10/601,127

Office Action Summary	Application No. 10/601,127	Applicant(s) SCHULER ET AL.	
	Examiner Darwin P. Erez	Art Unit 3773

DETAILED ACTION

Fig. 2(b)

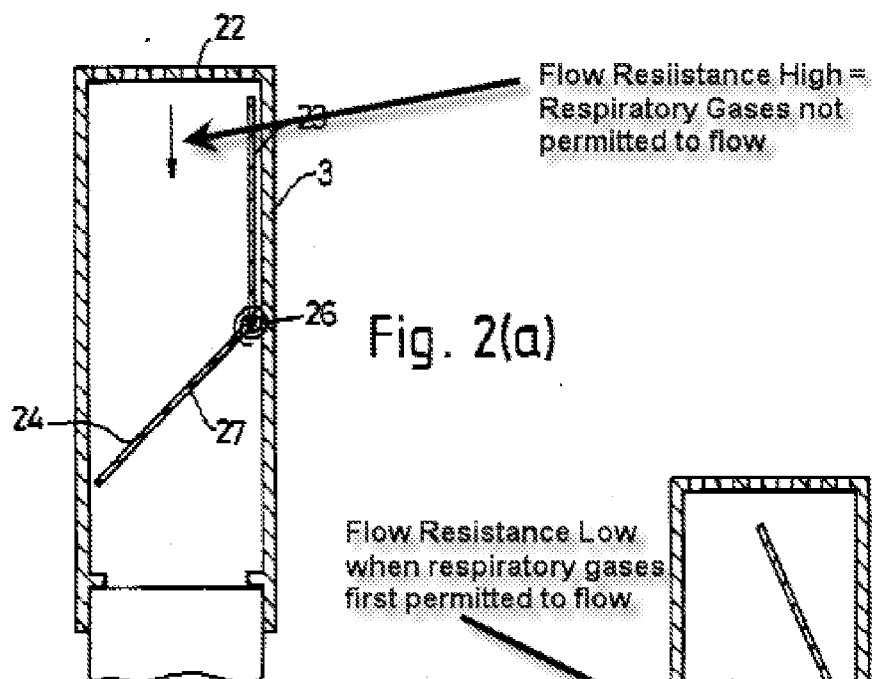
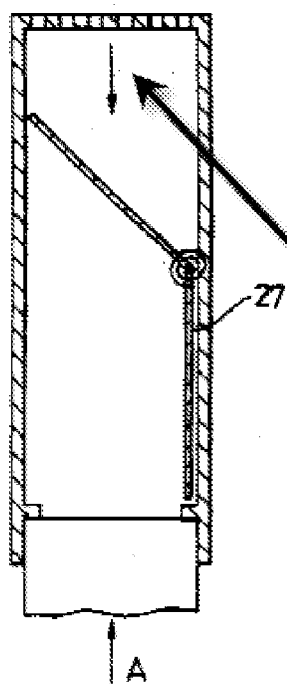
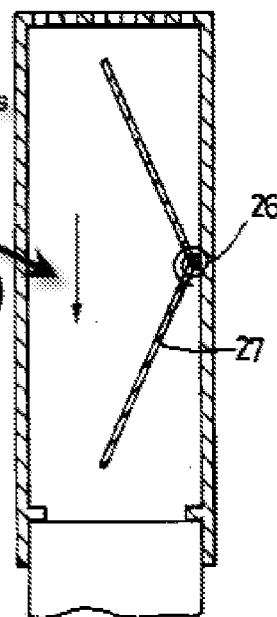
when the respiratory gases are permitted to flow and increases when the vacuum generated by the user increases thereafter (see attached figure below); and

Flow Resistance Low when respiratory gases first permitted to flow

Flow Resistance becomes High again when the user further reduces the negative pressure (col. 8, ll. 33-36)

With regard to the flow regulator limitation, the Examiner is interpreting vane portion 24 as said flow regulator. Vane portion 24 "varies the flow resistance through the airway to control the flow of respiratory gases". It is also noted that vane portion 24 provides a low flow resistance when the respiratory gases are permitted to flow, when the vane portion transitions from the position shown in Fig. 2(a) to Fig. 2(b). The position shown in Fig. 2(b) is interpreted as the position when "respiratory gases are

permitted to flow". Vane portion 24 increases the flow resistance when the inspiration rate is too much, as shown in Fig. 2(c).
